## **ADDENDUM No. 1**

### **Hayden Area Regional Sewer Board (HARSB) HARSB Phase 2 Tertiary Treatment and Biosolids Project Kootenai County, Idaho**

July 30<sup>th</sup>, 2021

Addendum No. 1 to the **HARSB Phase 2 Tertiary Treatment and Biosolids Project** Bidding Documents prepared by J-U-B Engineers, Inc., WesTech Engineering, and Aqua Engineering is hereby submitted for use in bid preparation and submittal. The following clarifications, corrections, or changes are hereby made as fully and completely as if the same were entirely set forth in the Bidding Documents, and shall become an integral part of any contract entered into between the Owner and Contractor for this project.

### **Drawing CU00-001**

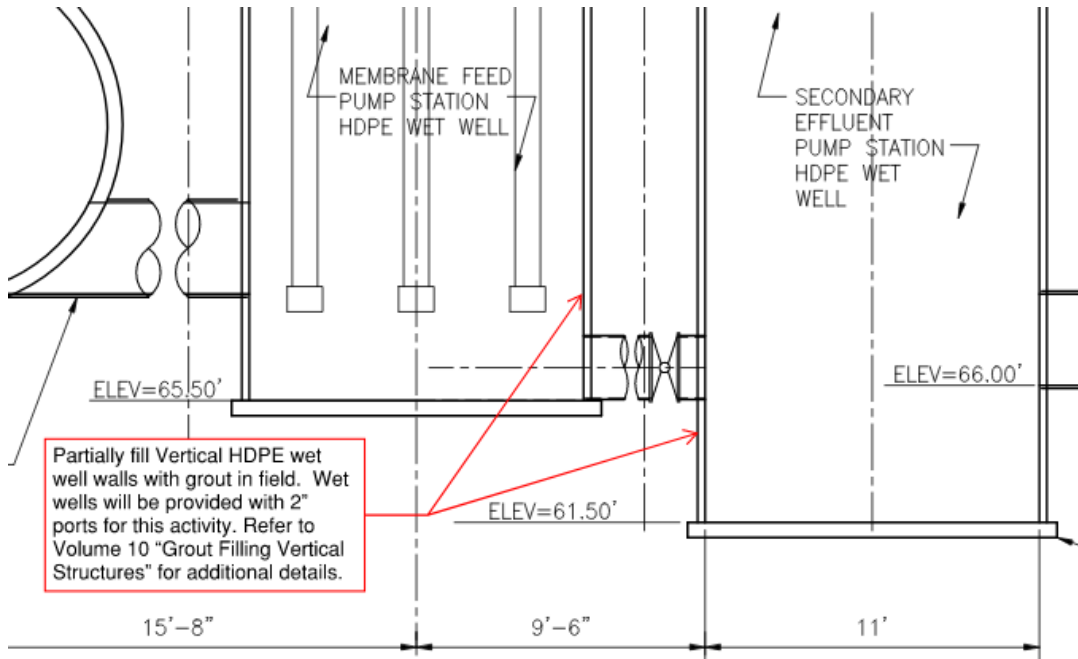
Add excavation depth to Yard Piping Note #16 as follows:

"... Contractor responsible for providing excavation of trench to a depth of 42" below finished grade, Avista-approved sand for bedding, backfill, and compaction..."
